PLANNING COMMISSION  
MEETING AGENDA  
NOVEMBER 14, 2023  
7:00 P.M.

**Wawa  
390 Glensprings Drive  
Corridor Review District  
Application# 2023-0764  
November 14, 2023**

**Chick-fil-A**  
**501 East Kemper Road**  
**Modification to a PUD and Zone Map Amendment**  
**Application# 2023-0739**  
**November 14, 2023**

**CHICK-FIL-A**  
**501 E. KEMPER ROAD**  
**PLAN REVIEW APP # 20230739**  
**19020115**  
**NOVEMBER 10, 2023**

**1 FRONT - EAST ELEVATION**  
3/16" = 1'-0"

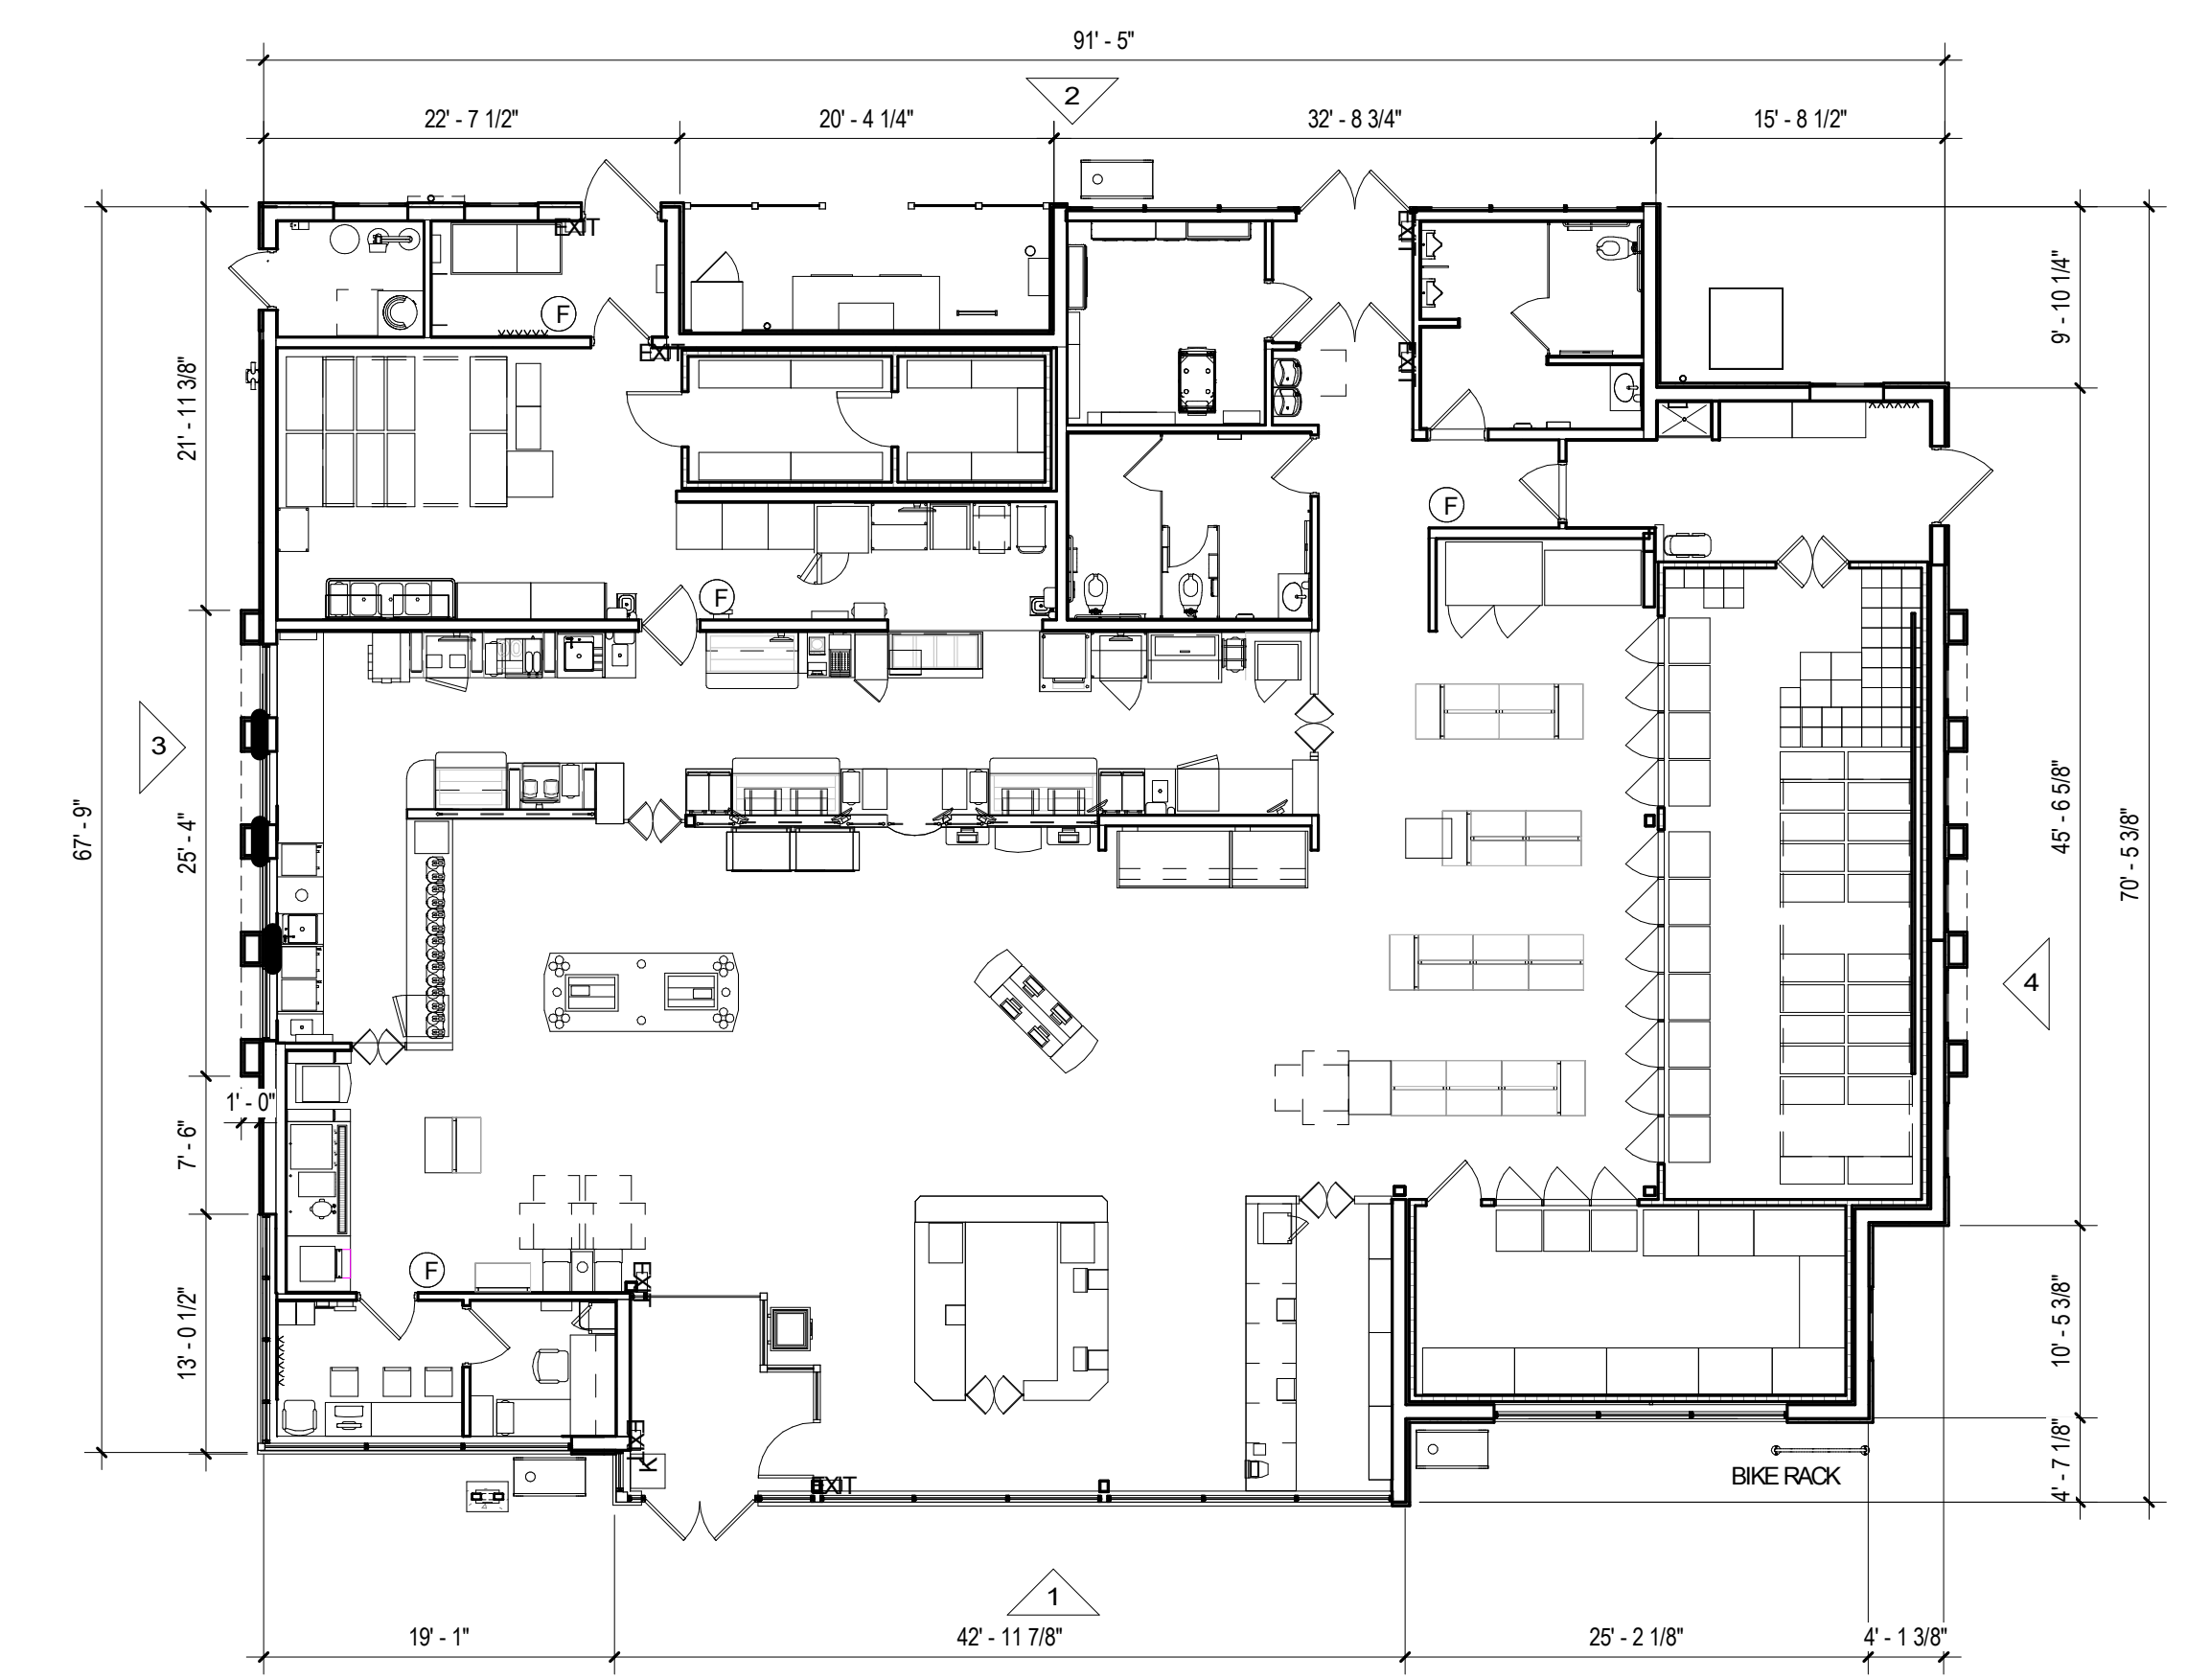
The site is located within Sub Area “B” of the Corridor Review District (“CRD”). Per Section 153.257 (C) (2) (c), the use of non-earthtone colors is limited to 10% of any elevation. The applicant is proposing the following use of colors:

Front / East Elevation:

Total Elevation Area: 1,822 SF  
Non-Earthtone Color Area: 80 SF (4.5 %)

Rear / West Elevation:

Total Elevation Area: 1,756 SF  
Non-Earthtone Color Area: 45 SF (3.0 %)

Side / South Elevation:

Total Elevation Area: 1,346 SF  
Non-Earthtone Color Area: 26 SF (4.0 %)

Side / North Elevation:

Total Elevation Area: 1,378 SF  
Non-Earthtone Color Area: 24 SF (1.7 %)

The only use of non-earthtone colors in the “ATAS #17 Bright Red” which is used on the metal overhangs. The paint is a powder coat Pantone PMS 186C. Given that the area of non-earthtone colors is significantly below the 10% permitted, staff believes the request should be approved.

SHEET NUMBER  
**C200**

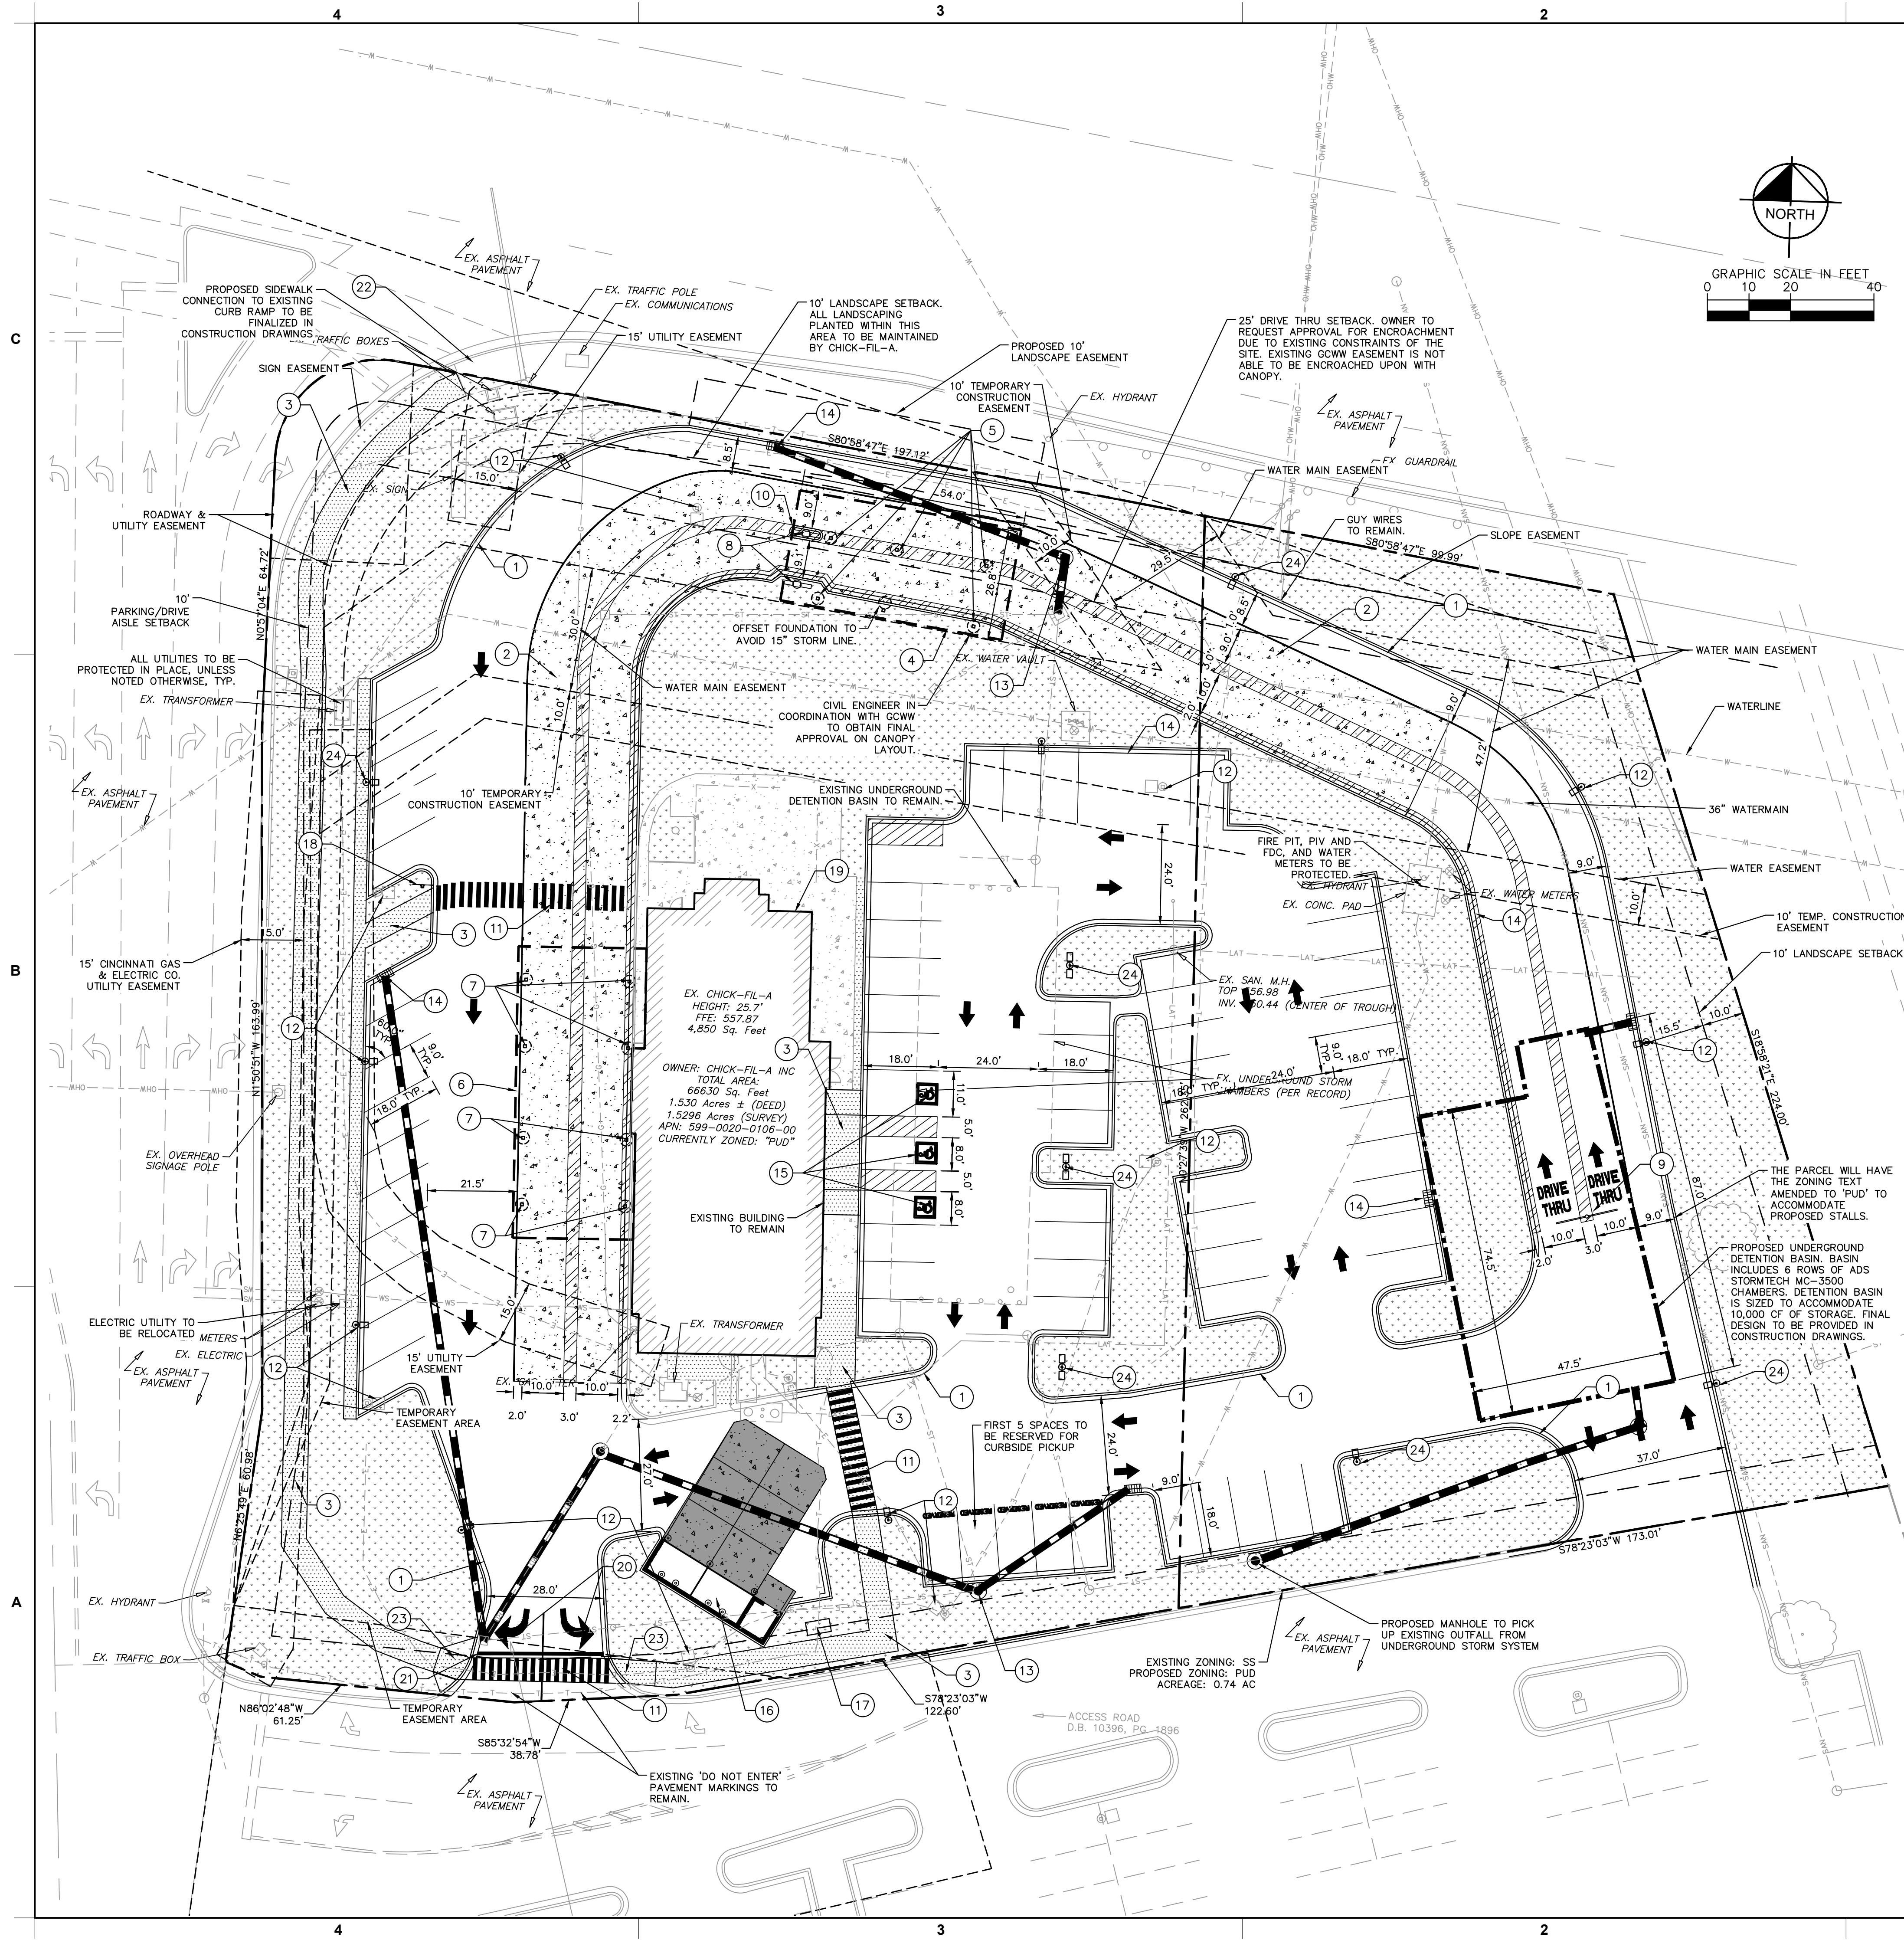
back from public or private/access drives 10 feet to the north (adjacent to East Kemper Road) or the south (adjacent to the private access drive). The applicant indicates in written correspondence that all the setbacks will be 10 feet, consistent with Section 153.404 (G) however, Sheet C-200 still shows setbacks below 10 feet and landscaping in the bypass lane.

- 4) The proposed drive thru stacking lanes are indicated to be 9 feet in width where 10 feet is required per Section 153.304 (B) (1). In written correspondence, the applicant indicates that the stacking aisles will be 10' wide, however Sheet C-200 shows them as 9' wide.

- 6) Section 153.302 (D) (5) requires the bypass access drive to be a minimum of 10 feet in width. Sheet C-200 indicates the bypass access is to be only 9' in width.

- 7) To provide a safe pedestrian connection across the drive aisle and two drive thru lanes on the west side of the store, a flashing Ped X sign needs to be provided at the crosswalk. The applicant has indicated such a sign on Sheet C-200.

- 6) The applicant provide the proposed setbacks for the drive thru stacking lanes and Planning Commission determine if the proposed setback is appropriate.
